RE: Lost Creek ISR LLC, In-Situ Recovery (ISR) Permit Application, TFN 4 6/268, 3rd Round Technical Review Comments

Subject: Third round of Technical Review comments on Lost Creek ISR Application,
TFN 4 6/268

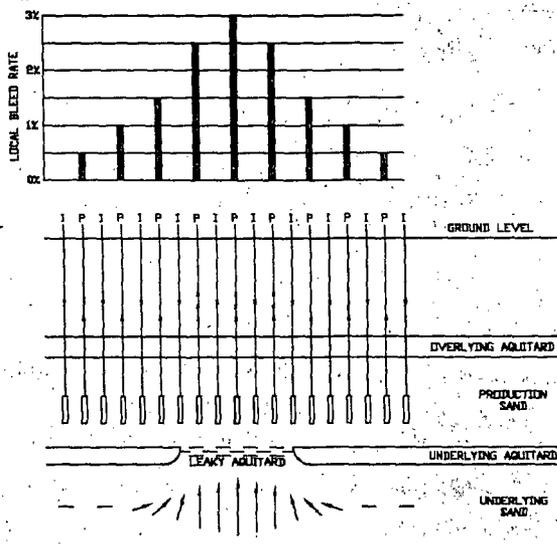
LQD (11/09) - Response not acceptable. *Section OP 3.6.3.3 still states that the "LC ISR LLC will apply for a permit revision to conduct ISR in the overlying FG and underlying KM sands" If it is known that these units will be mined, then appropriate baseline studies must be conducted prior to any mining, which would likely result in disruption of the baseline conditions. If mining in these units is not anticipated, then the statement in Section OP 3.6.3.3 should be dropped. (AB and MM)*

LC ISR, LLC (2/10) - The reference to mining in other sands has been removed from Section OP 3.6.3.3.

LQD (3/10) The reference to future mining in the KM sands has been removed, therefore at this point in the permitting process, the sand underlying the KM does not require baseline analysis. Prior to any mining in the KM, the underlying sand will need to be fully characterized. **This item is resolved.** (AB)
